**Ministerial Planning Referral: TPM-2014-5
49-61 Coventry Street (and 26-66 Dorcas Street), Southbank**

6 May 2014

PLANNING REPORT

MINISTERIAL REFERRAL

TITLE
GROUND LEVEL

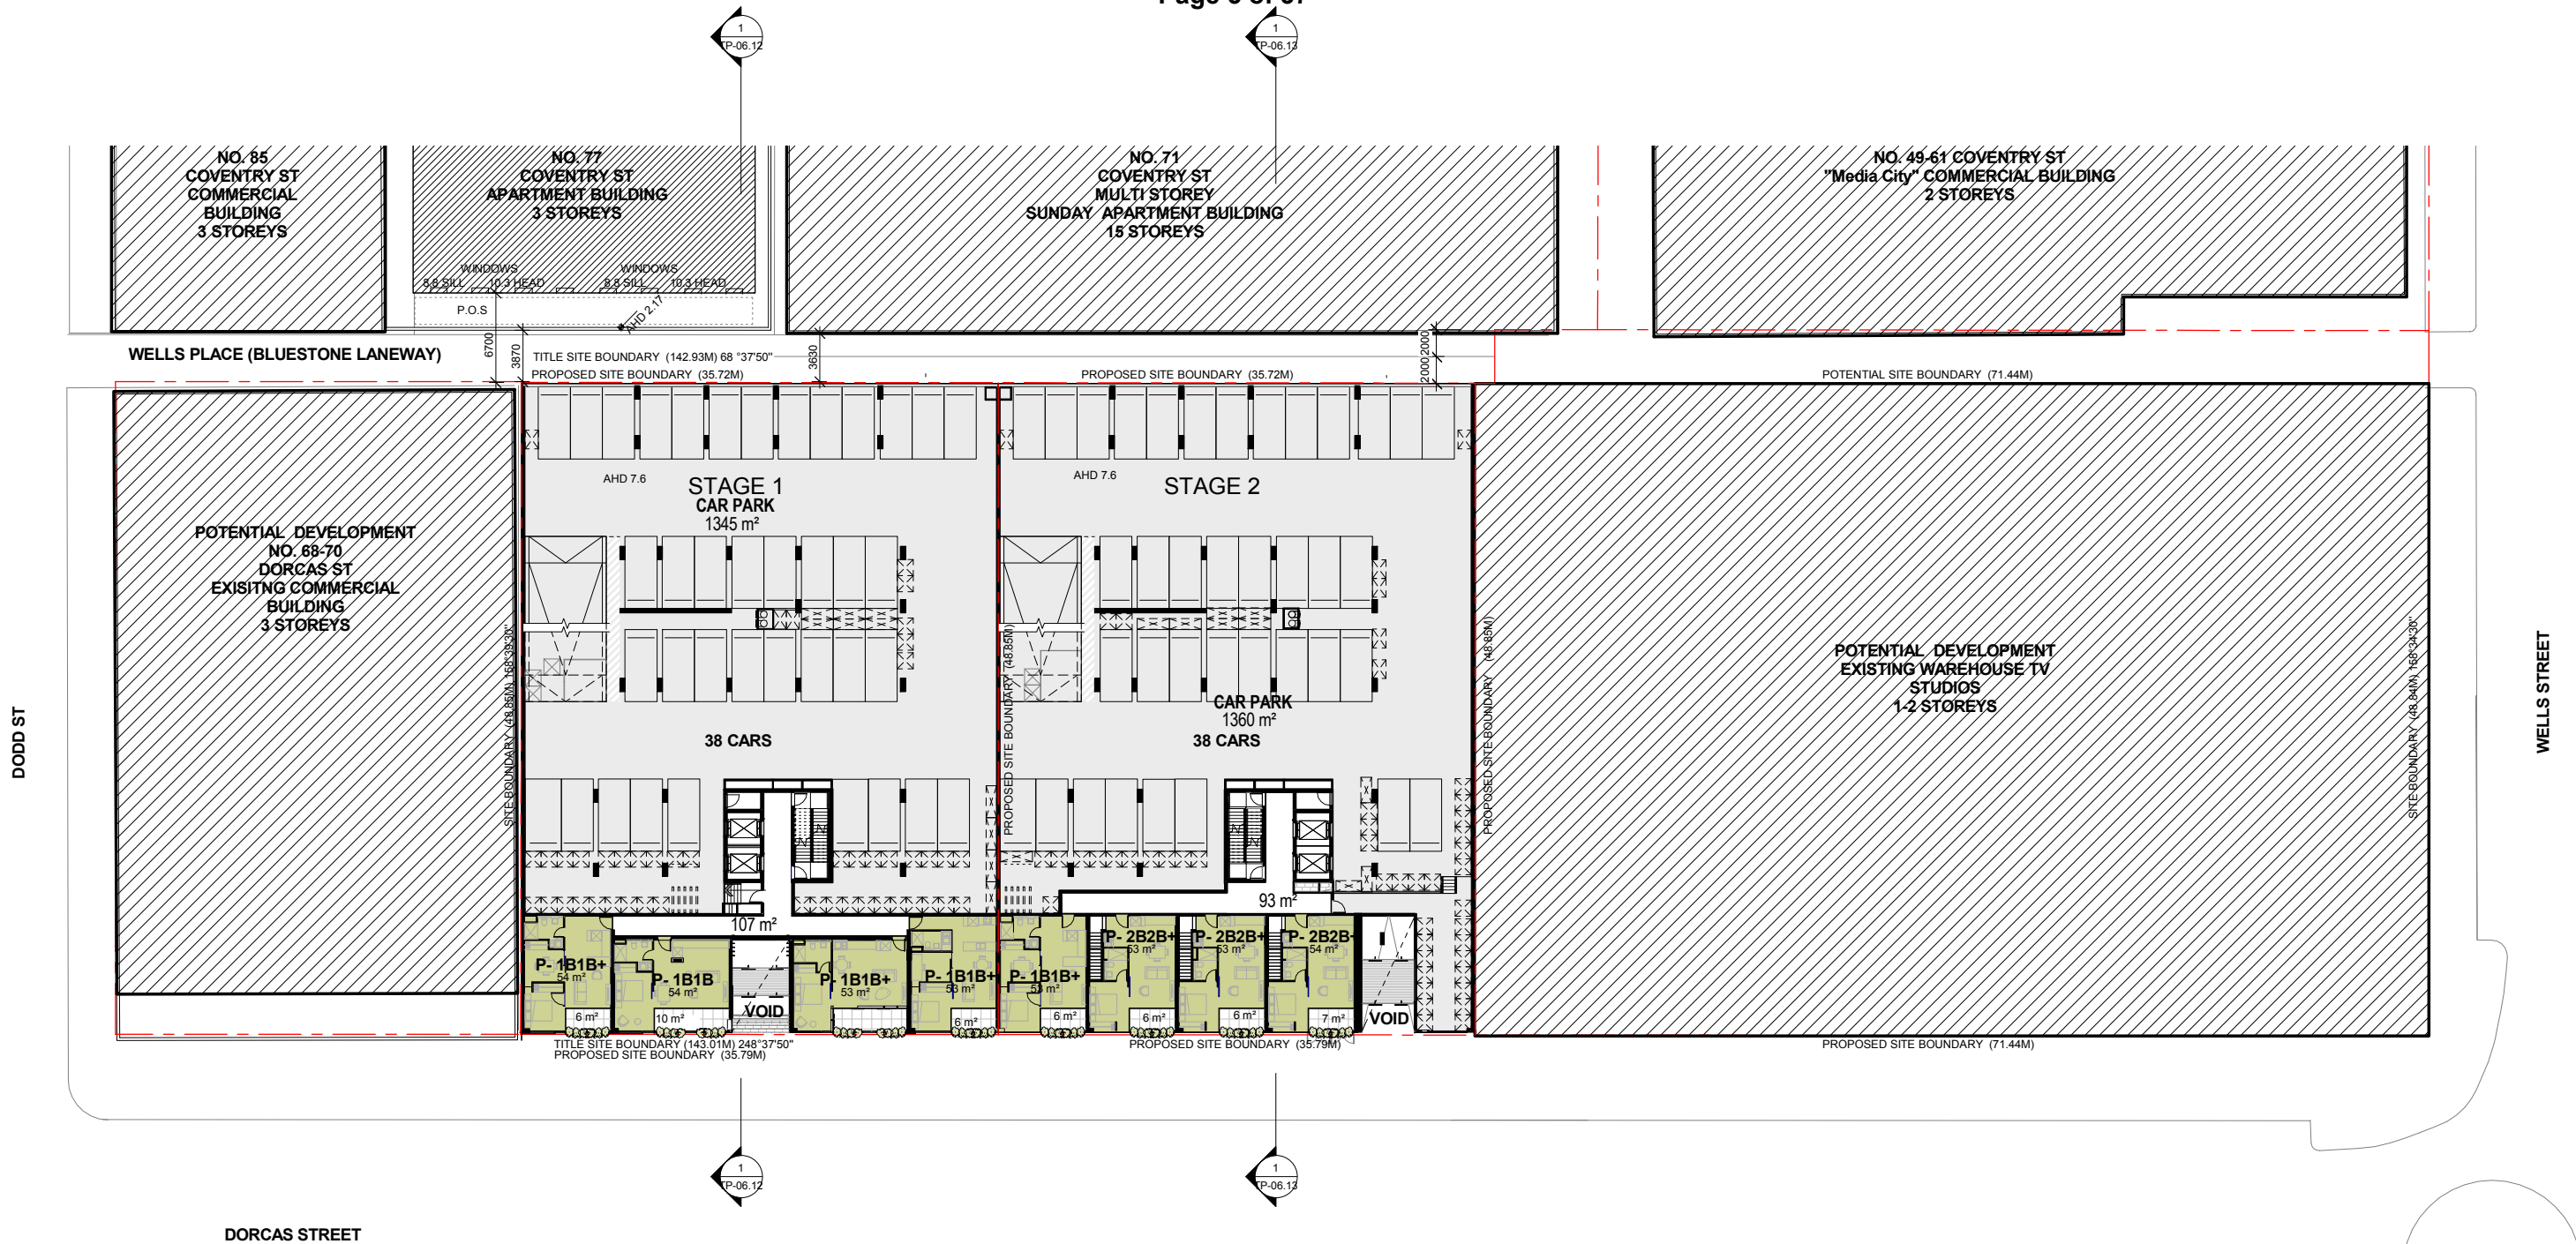
- Loading and unloading for the food and drink premises and residents will be able to be accommodated by on-street parking areas on Dorcas Street.
- Plans show the proposed crossover to Dorcas Street has a width of 11.5m. Crossings in excess of 7.6m are required to provide a pedestrian refuge with a minimum width of 2m. Recommend that a pedestrian refuge of at least 2m be provide at the front of the planter box, at the proposed crossover to Dorcas Street.

- The food and drink premises adjacent to the exit lane may impact on pedestrian sight lines. Additional information required to demonstrate the sight line triangle.

Two existing crossovers will be removed from the frontage of the site, thereby improving the pedestrian amenity and accessibility along Dorcas Street. The replacement double crossover however has a width of 11.5m, and does not provide a pedestrian refuge. Engineering Services Group recommend a pedestrian refuge of at least 2m be provided at the front of the planter box at the proposed crossover to Dorcas Street.

1. Prior to the commencement of the development on the land, two copies of plans, drawn to scale, must be submitted to the Responsible Authority generally in accordance with the plans received on 23/12/2013 but amended to show:
 - a. The height of the building reduced to 60 metres (excluding plant), measured at ground level at the centre of the Dorcas Street frontage;
 - b. The tower setback a minimum of eight metres from the eastern boundary of the development site.
 - c. Sufficient setback of ground floor stairs from the Dorcas Street property boundary so as to enable all necessary tactile ground surface indicators to be installed within the property boundary;
 - d. The provision of a 2m wide pedestrian refuge at the front of the planter box at the proposed crossover to Dorcas Street;

- h. Demonstration that a sight triangle will be provided in accordance with Clause 52.06 for the exit lane adjacent to the food and drink premises;
- i. Modification or shifting of storage cages located adjacent to parking spaces so as to not compromise the door opening area of the clearance envelope;

TITLE
SOUTH ELEVATION STAGE 1 & 2

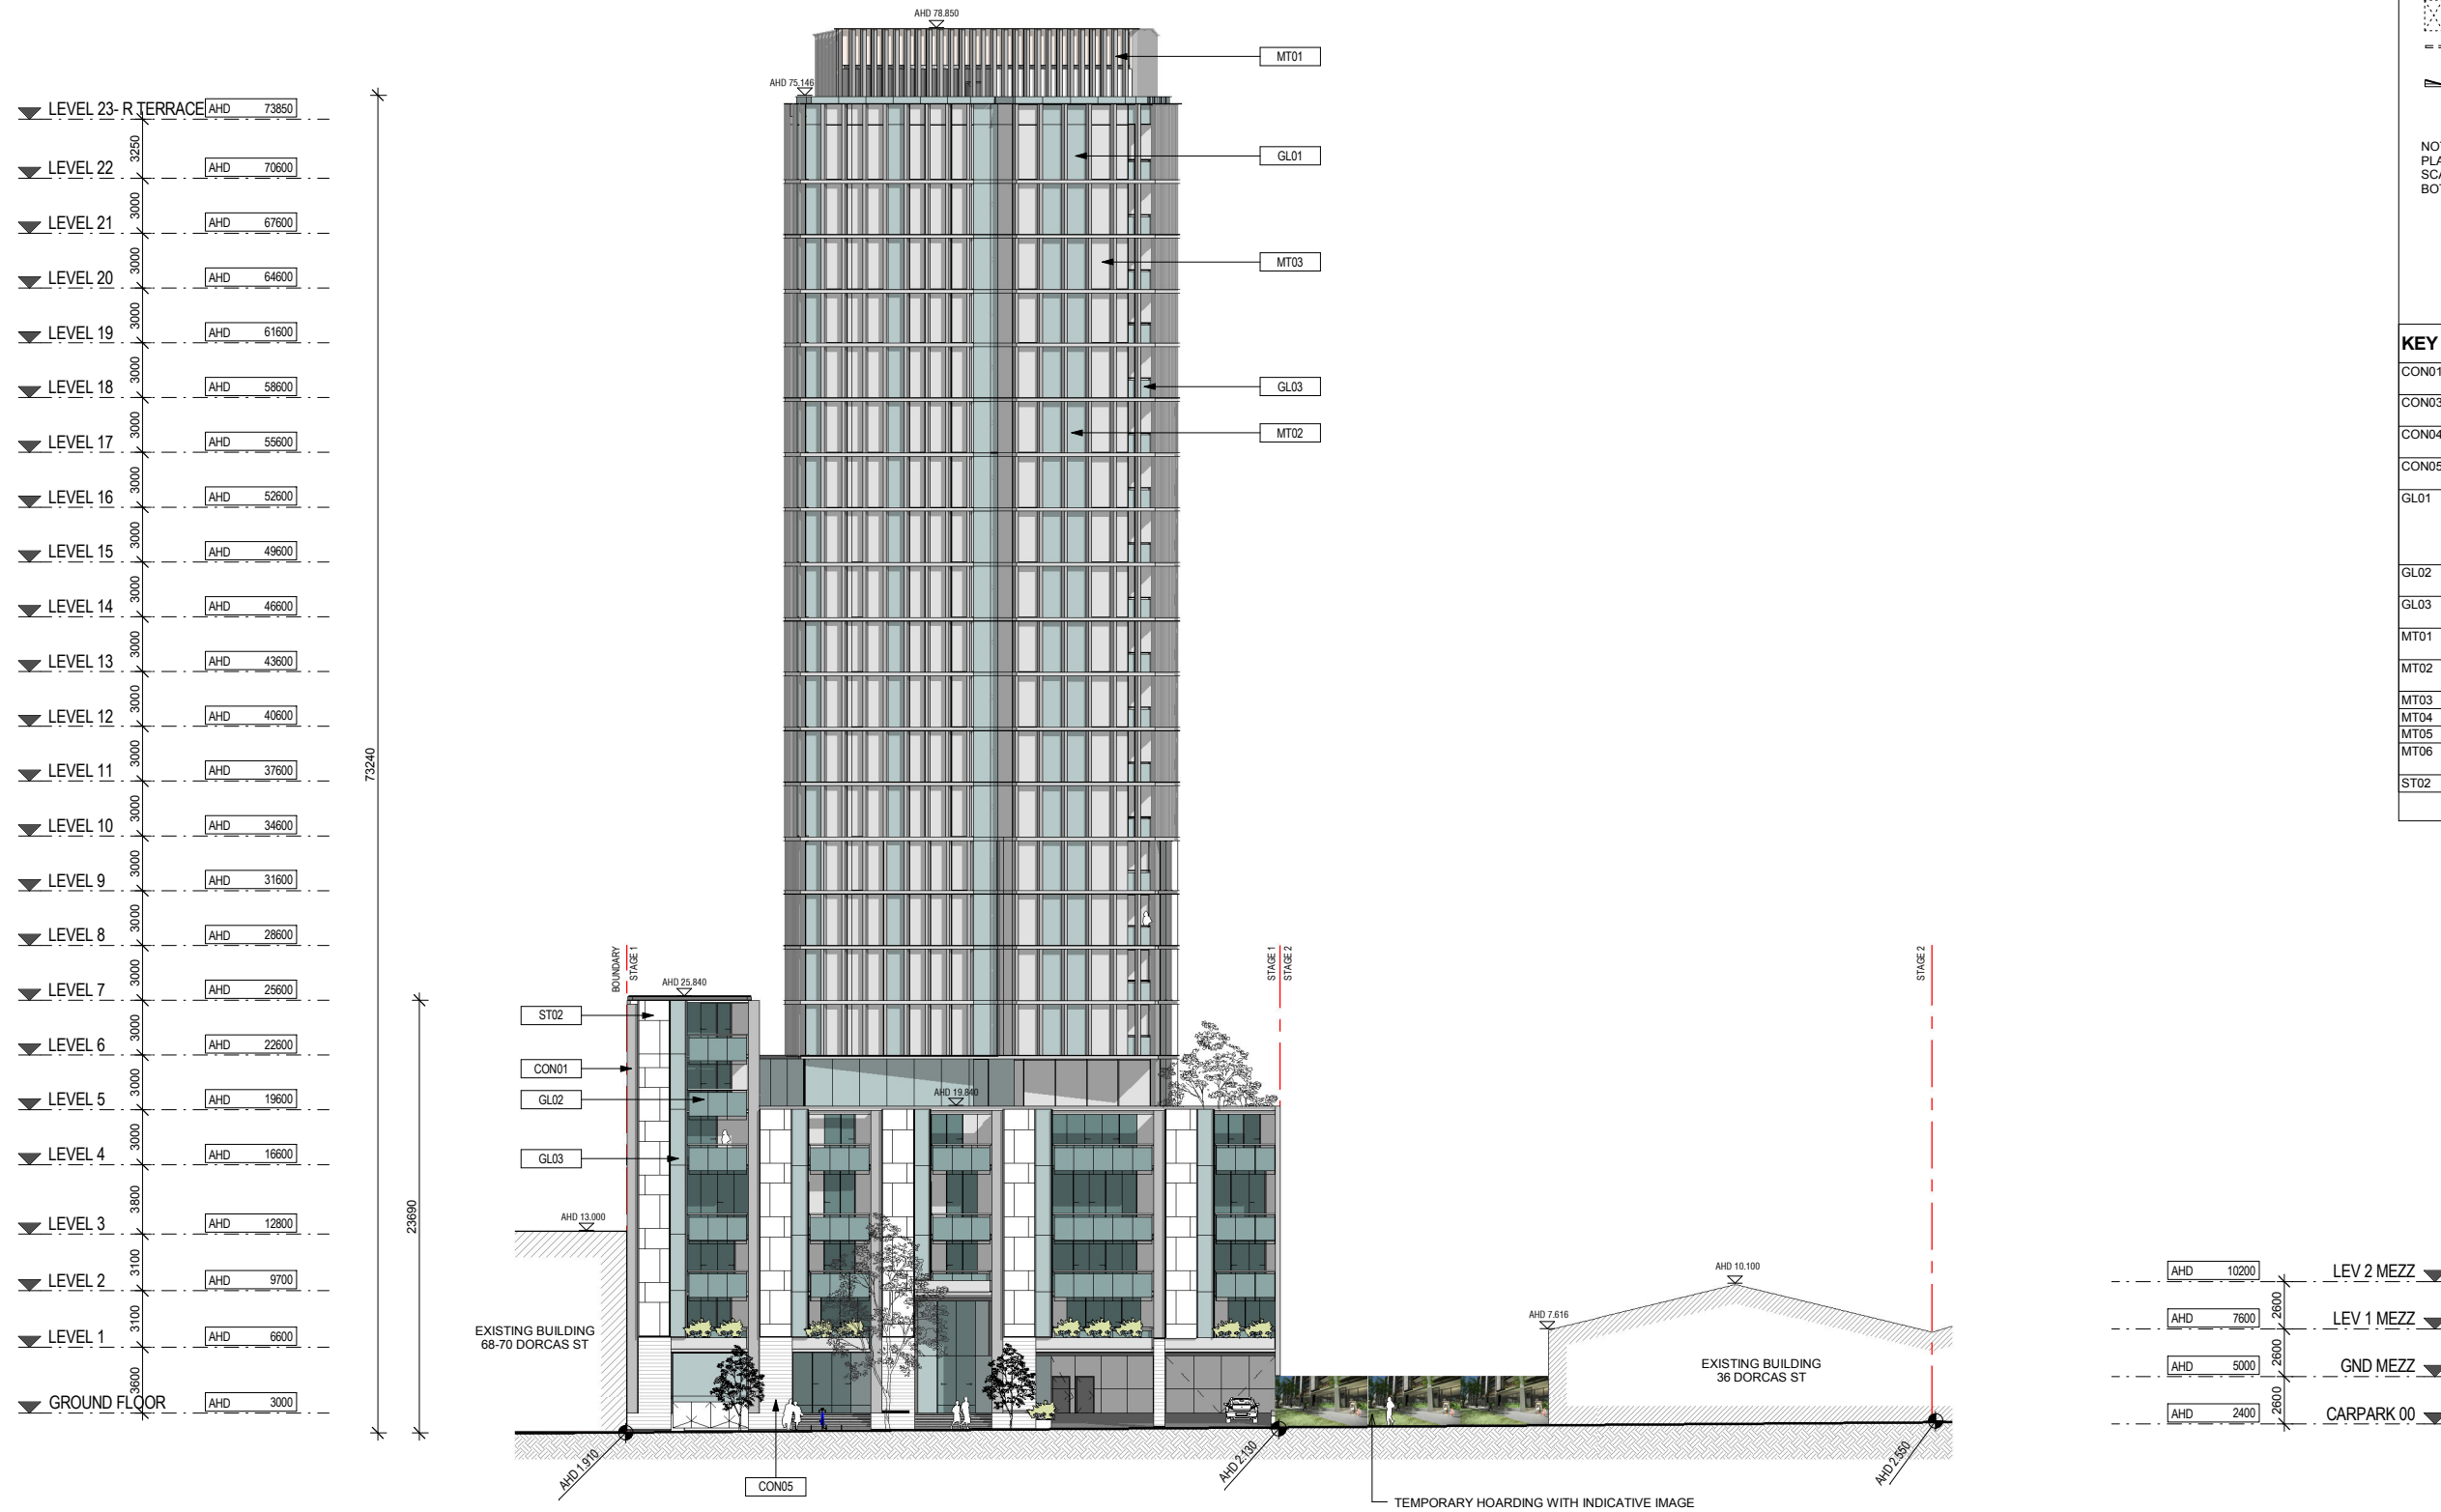
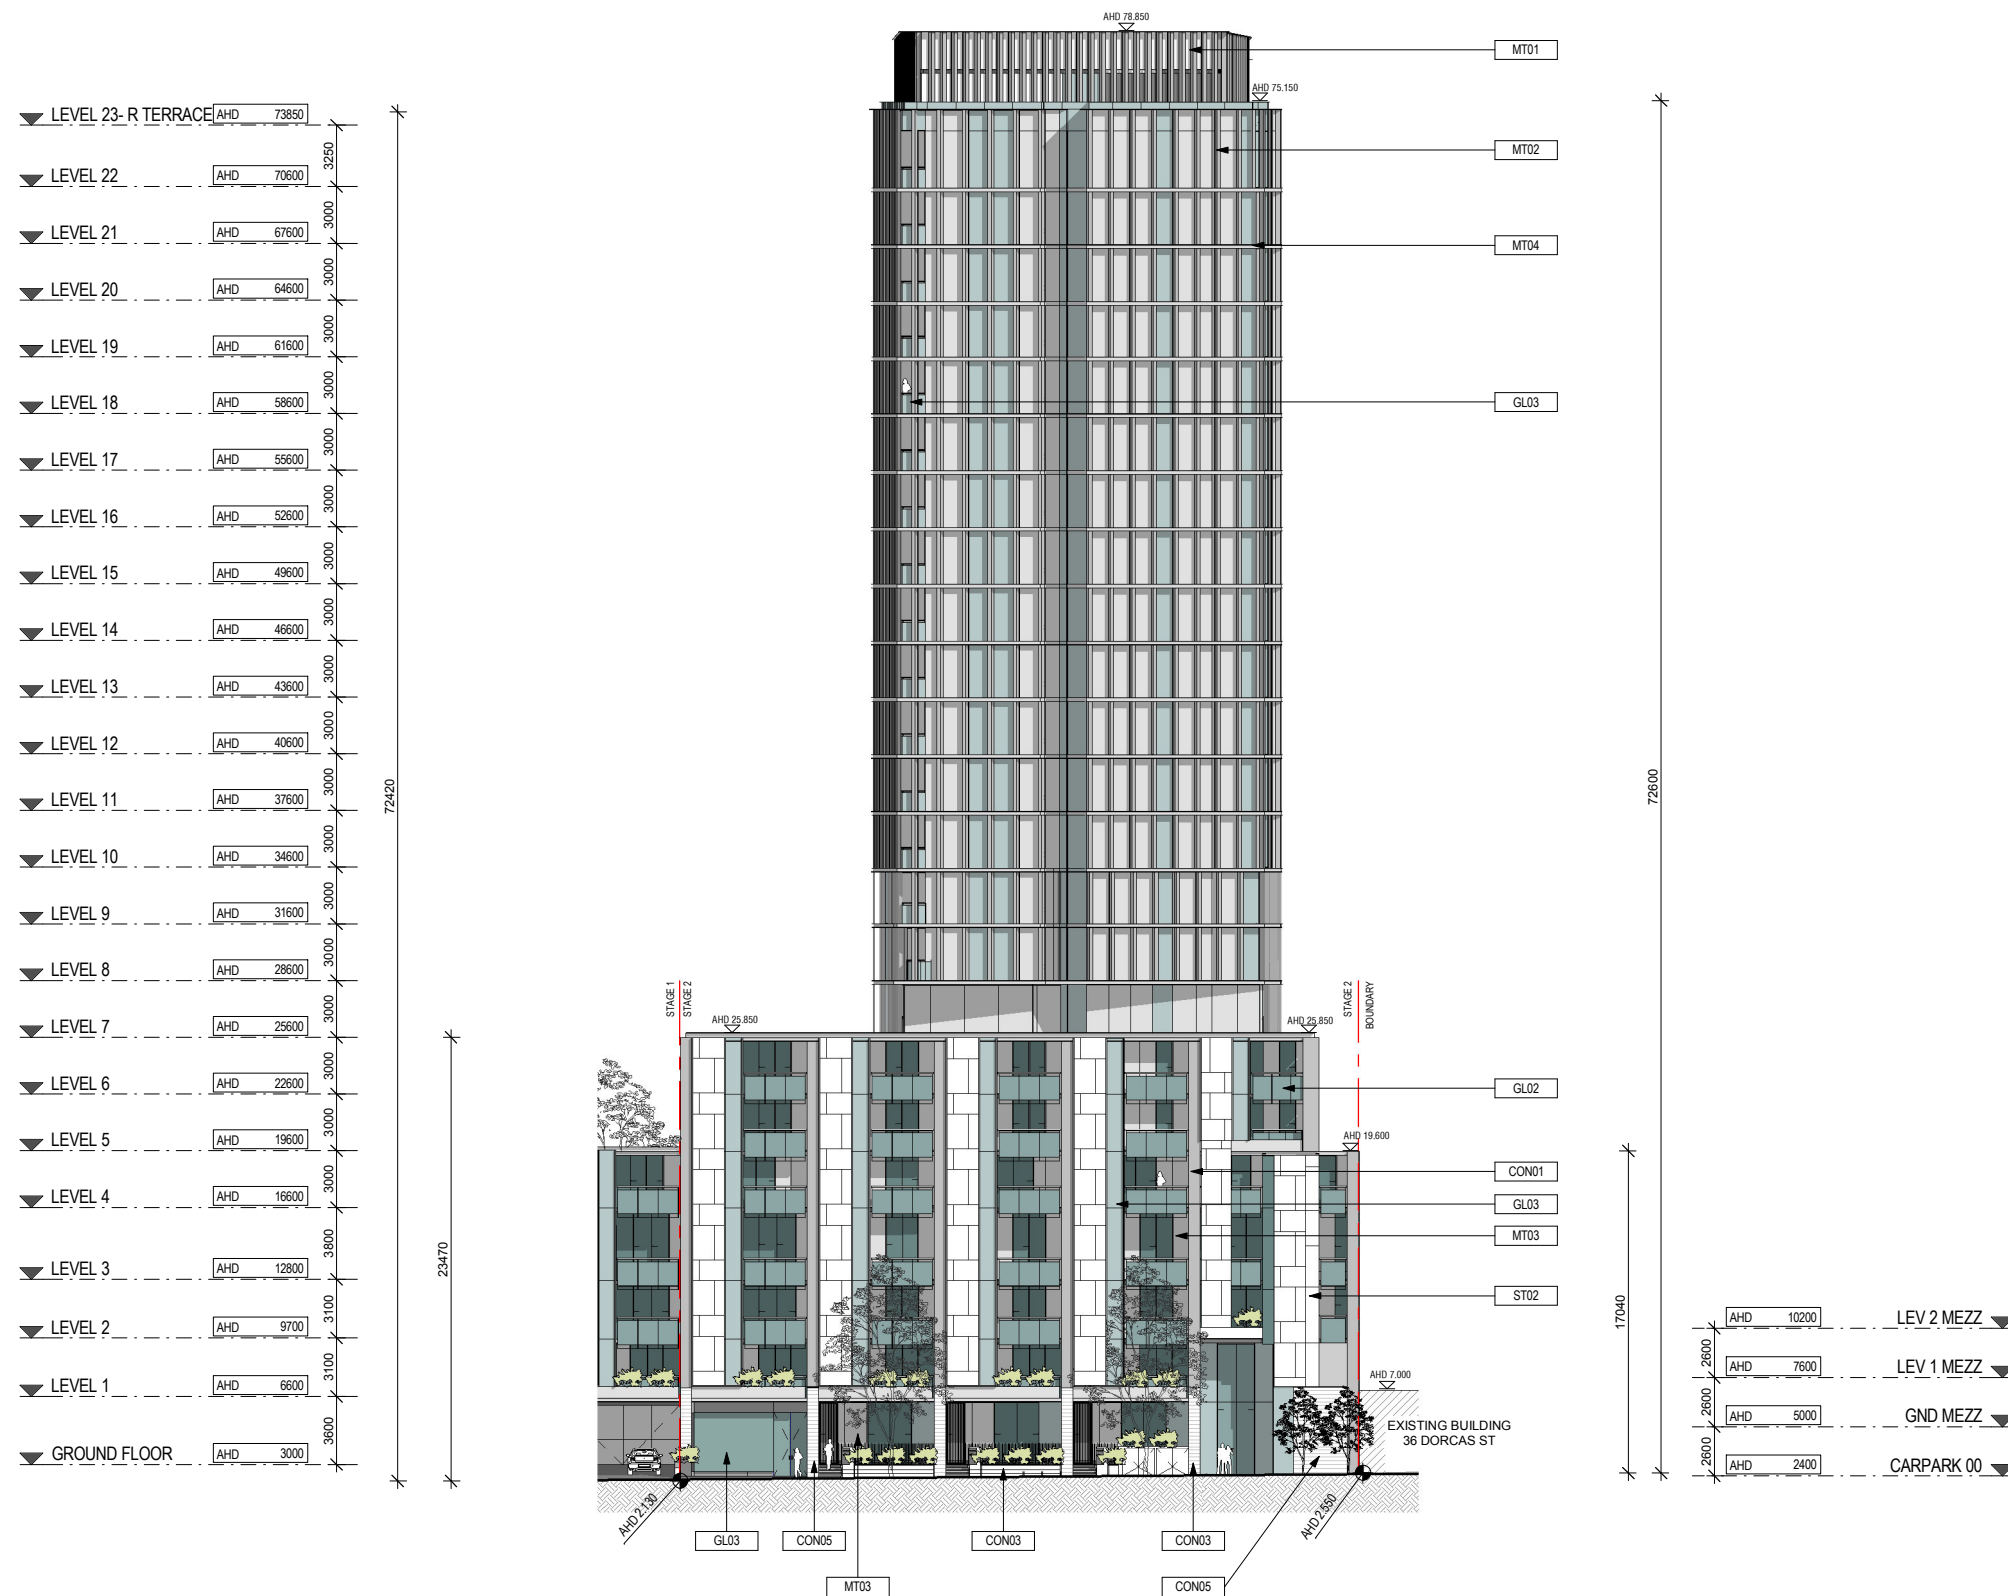
- 6.1.1. The height of the towers exceeds the maximum building height under the Design and Development Overlay and the height is inappropriate in the context of existing surrounding buildings in both the City of Melbourne and the City of Port Phillip.

- 6.1.2. The setback from the eastern boundary is insufficient having regard to the development potential of adjoining sites and the requirements of the Design and Development Overlay.

- Encourages the applicant to explore alternative development typologies, eg. perimeter block development.
- Support the varying podium heights.
- Proposed height at 73m exceeds the 60m discretionary limit.

- Questionable whether the height satisfies the built form outcomes of the DDO given that it is 28m taller than the Sunday Apartments to the north and about double the height of the buildings on the south side of Dorcas Street.

- The boundary setbacks are all less than the 10m recommended in the DDO.
- Correspondingly, the proposed tower separations are less than 20m, varying between about 10m to the balconies of the Sunday Apartments) and 18m between the two proposed towers.

- 6.2. This objection could be considered to be withdrawn if the overall height of the development is reduced to 60 metres excluding plant and the setbacks to the eastern boundary are increased to a minimum of eight metres. This may result in a higher podium and a lesser tower setback to Dorcas Street.
